Contract #: 04-0120F4Cty: SF/ALA Rte: 80 PM: 13.2/13.9File #: 69.25B**QUALITY ASSURANCE -- NON-CONFORMANCE REPORT****Location:** Changxing Island, Shanghai, PRC**Report No:** NCR-000426**Prime Contractor:** American Bridge/Fluor Enterprises, a JV**Date:** 22-Sep-2009**Submitting Contractor:** Zhenhua Port Machinery Company, Ltd (ZPMC), Changxing Island**NCR #:** ZPMC-0400**Type of problem:**

Reference Description: Unapproved welder welding on North Tower, Lift 4, Skin D Stiffener Connection Plates**Description of Non-Conformance:**

Subject: NCR No. ZPMC-0400

Reference Description: Unapproved Welder (4G) / North Shaft Lift 4 Skin D/ Stiffener Connection Plates Tack Welds

Tack Welder Certification as below:

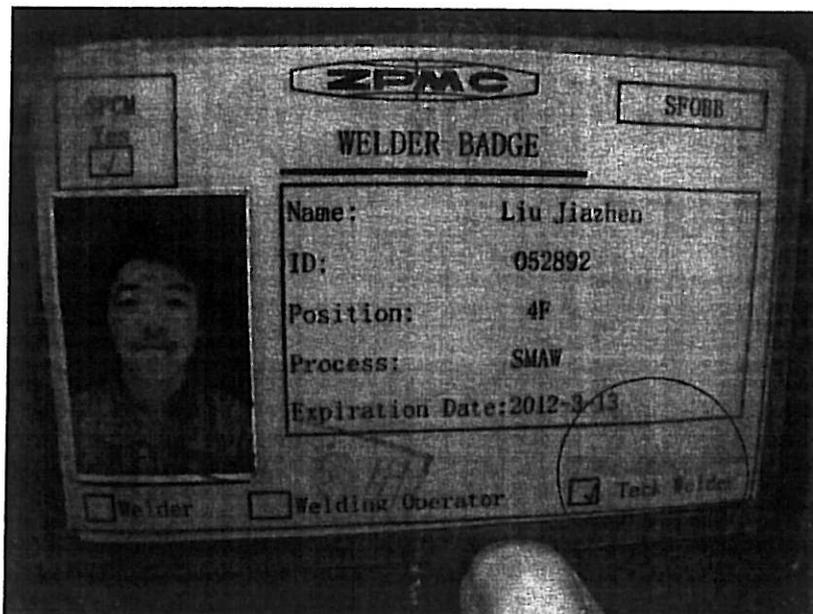
ZPMC received NCR-000426(ZPMC-0400), it mentioned that ZPMC's 4F qualified welder performed tack welding on 4G position. But according to AWS D1.5 Section 5.22.4: A tack welder who passed the fillet weld break test shall be eligible to tack weld all types of groove joints on fillets using the process and the welding position tested. Since this welder has the tack weld certification, and did comply with the AWS requirement, how did the Non-Conformance come?

Here attached the welder certification to show his qualification.

The Department has reviewed the applicable codes and found that it was in error in the issuance of NCR ZPMC-400. ZPMC/ABF JV is correct in their interpretation of the code. The Department will endeavor to prevent future occurrences and concurs that Non-Conformance ZPMC-400 is closed.
